Access Compliance Report

Public Rights-of-Way

(Curb Ramps)

Intersection ID: 44455	Main Street: AMES_HOLLOW_RD	Cross Street: BUCKHORN_ST	Location: SE
ADA ID: F3B50CA41477	Ramp Type: PerpDiag	Initial Pass/Fail: Fail	Overall Compliance: No
		Severity Score: 10

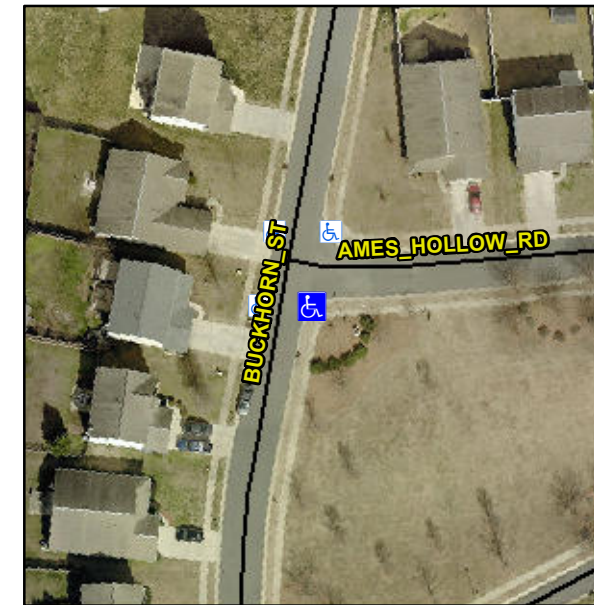
Not Found, R304.5.1, R304.5.3

Compliance	Description	Data	Compliance	Description	Data
N/A	Ramp Length (in)	53.0	Yes	Ramp Slope (%)	5.0
No	Ramp Width (in)	38.5	No	Ramp XSlope (%)	4.8
N/A	Flare Type LT	N/A	N/A	Flare Type RT	N/A
N/A	Flare Slope LT (%)	N/A	N/A	Flare Slope RT (%)	N/A
N/A	Flare Traversable LT?	N/A	N/A	Flare Traversable RT?	N/A
N/A	Landing Length (in)	N/A	N/A	DWS Provided?	N/A
N/A	Landing Width (in)	N/A	N/A	DWS Contrast?	N/A
N/A	Landing Slope (%)	N/A	N/A	DWS Length (in)	N/A
N/A	Landing X Slope (%)	N/A	N/A	DWS Full Width?	N/A
N/A	Landing Curb? (Y/N)	N/A	N/A	DWS Offset (in)	N/A
N/A	Shared Landing?	N/A			
N/A	Gutter Ponding?	N/A	N/A	Gutter Slope (%)	N/A
N/A	Gutter Lip Ht (in)	N/A	N/A	Gutter X Slope (%)	N/A
N/A	Painted X Walk1?	No	N/A	Painted X Walk2?	No
	X Walk 1 Direction	To N		X Walk 2 Direction	To W
N/A	X Walk 1 Width (in)	N/A	N/A	X Walk 2 Width (in)	N/A
	X Walk 1 Slope (%)	4.2		X Walk 2 Slope (%)	3.0
	X Walk 1 X Slope (%)	1.7		X Walk 2 X Slope (%)	1.9

Remove & Replace Curb Ramp With Two New Directional Ramps or Equivalent.
